LIBERTY TREE ACADEMY
FINAL DRAINAGE REPORT

Project Number: 18.995.001

PPR-18-023

LIBERTY TREE ACADEMY
DRAFT DRAINAGE PLAN
FIGURE A-1. PROPOSED DRAINAGE PLAN

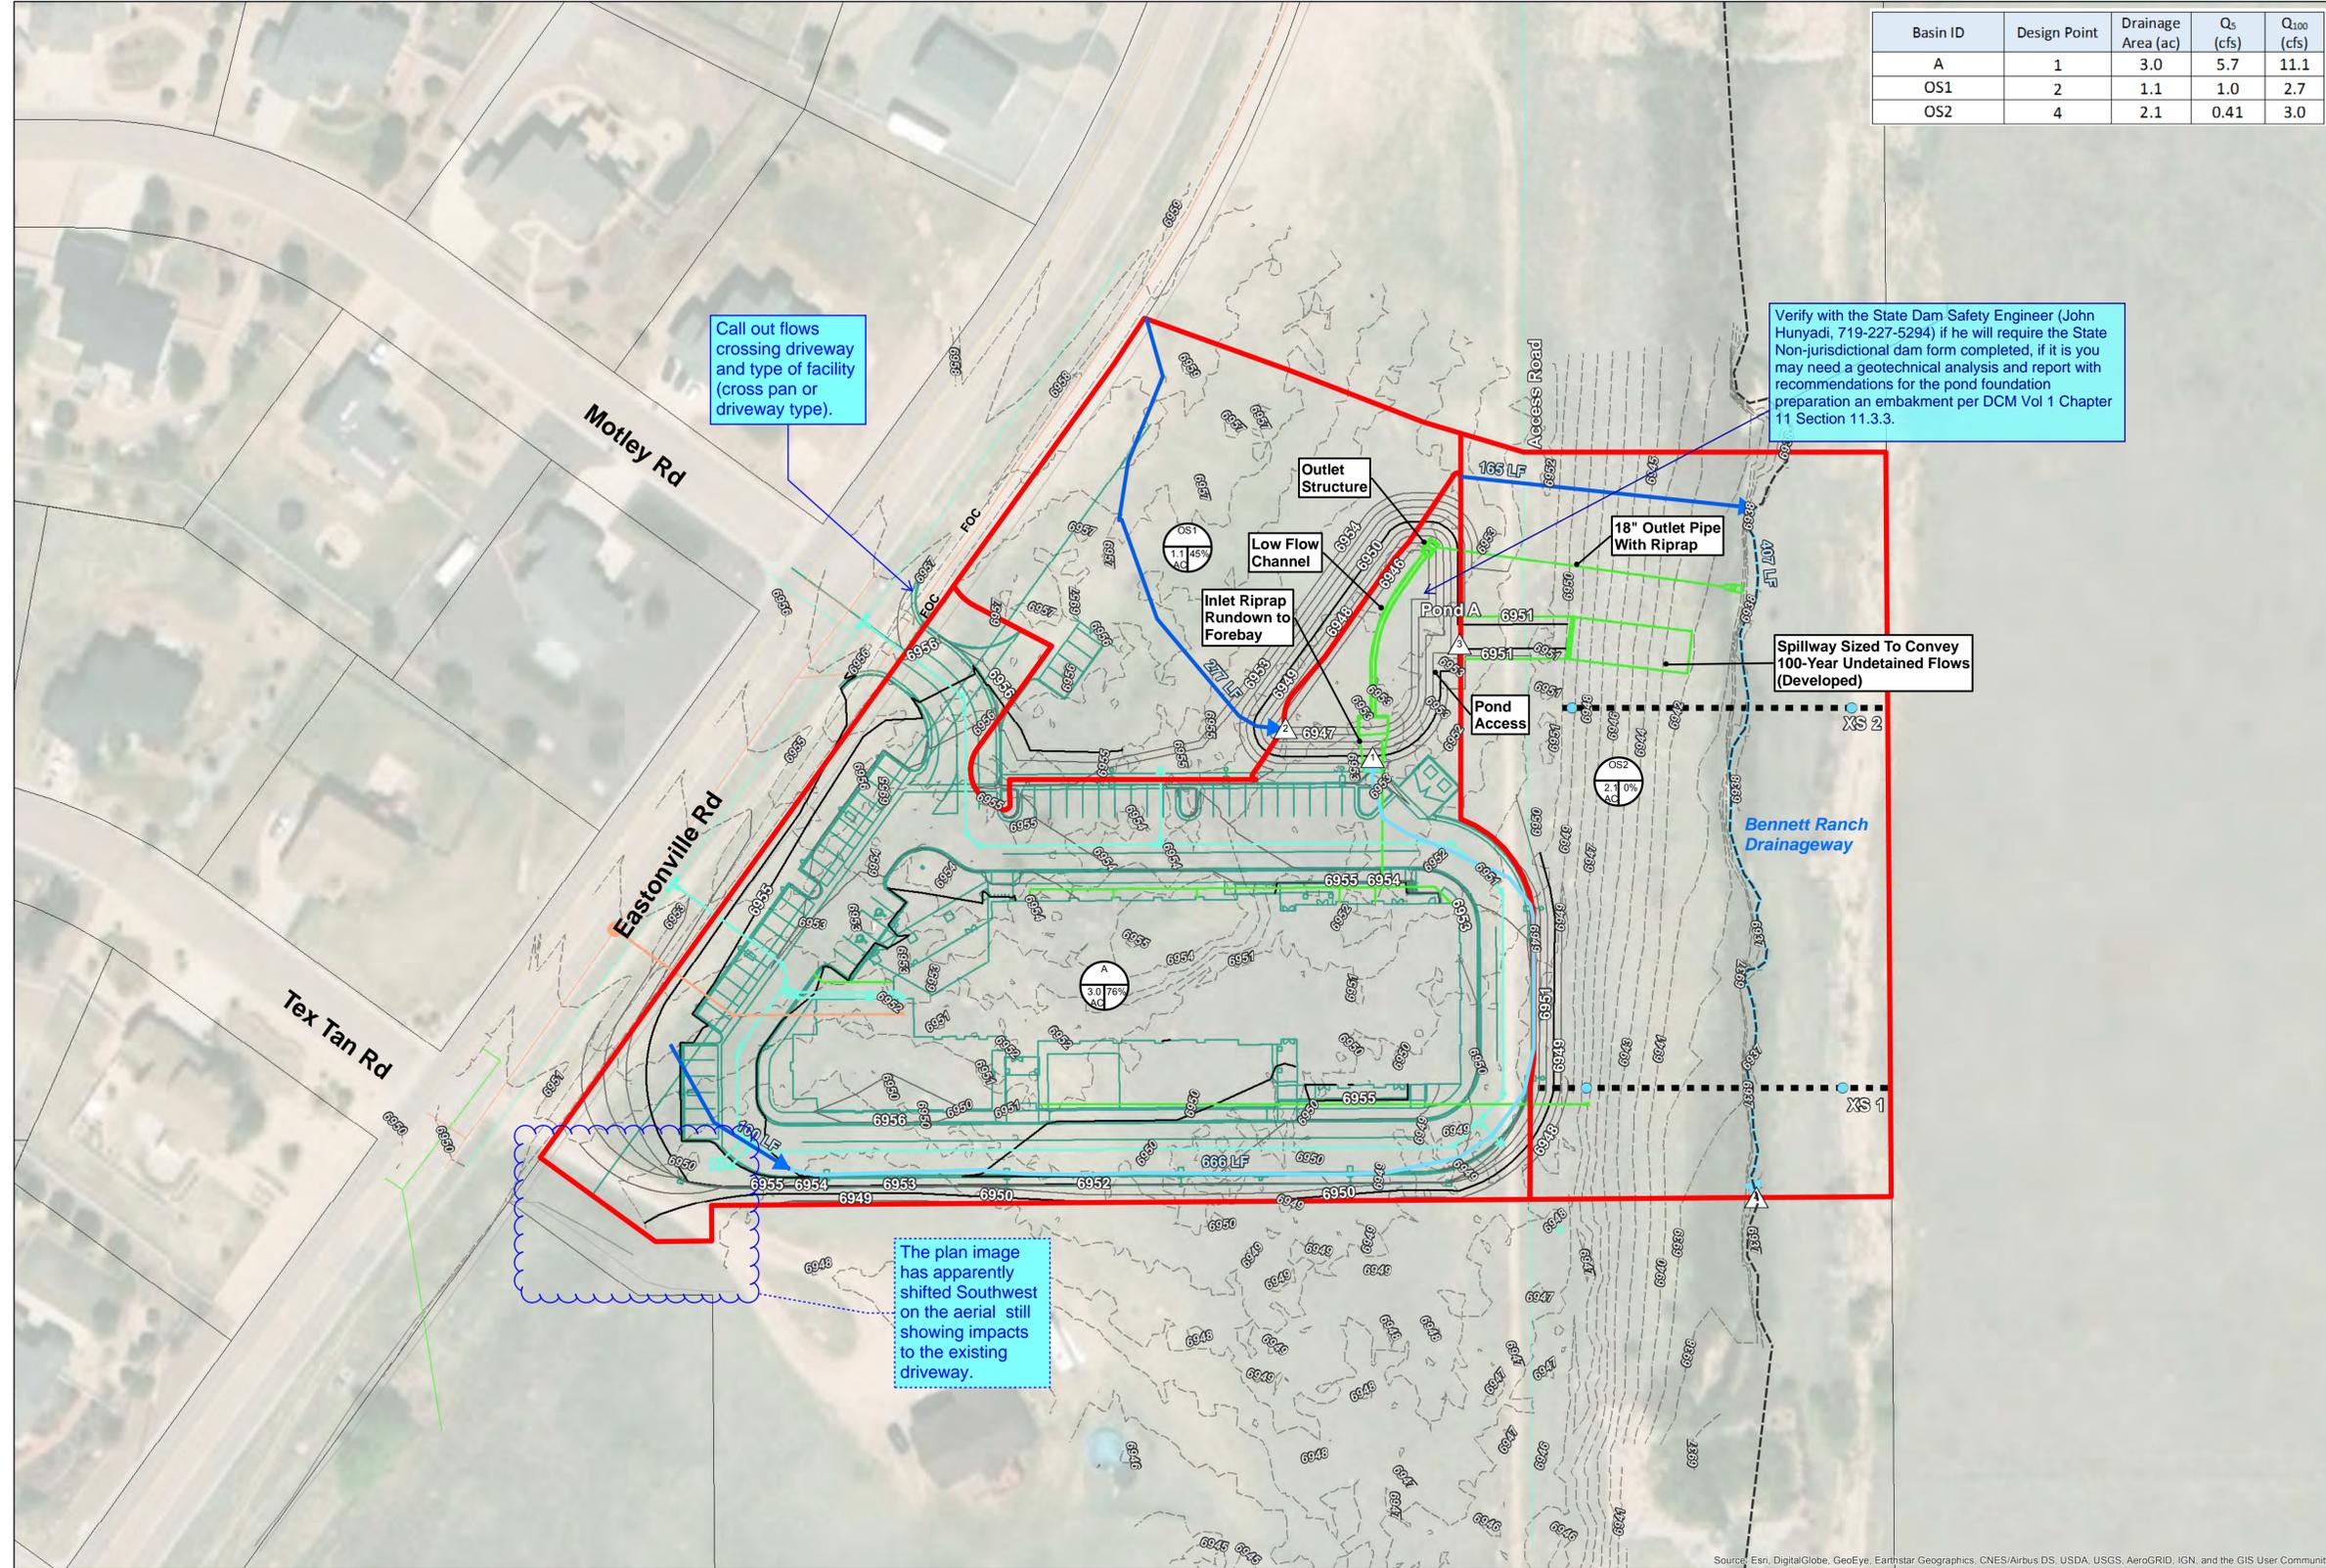
The plan image has apparently shifted Southwest on the aerial still showing impacts to the existing driveway.

Detention Basin Outlet Structure Design

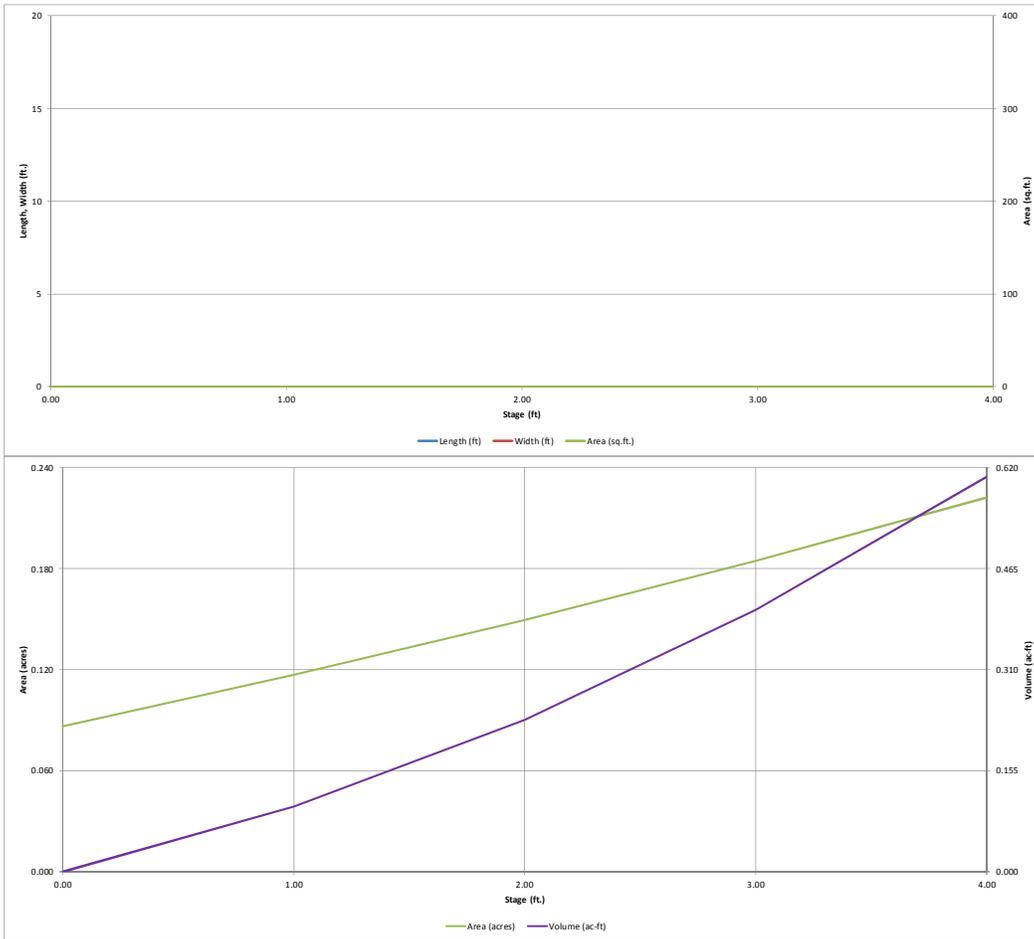
Depth to Invert does not match the construction drawings.

Per UDFCD full spectrum detention facility is designed to reduce the developed condition 100yr peak discharge to 90% of the pre-development 100-yr peak flow rate.
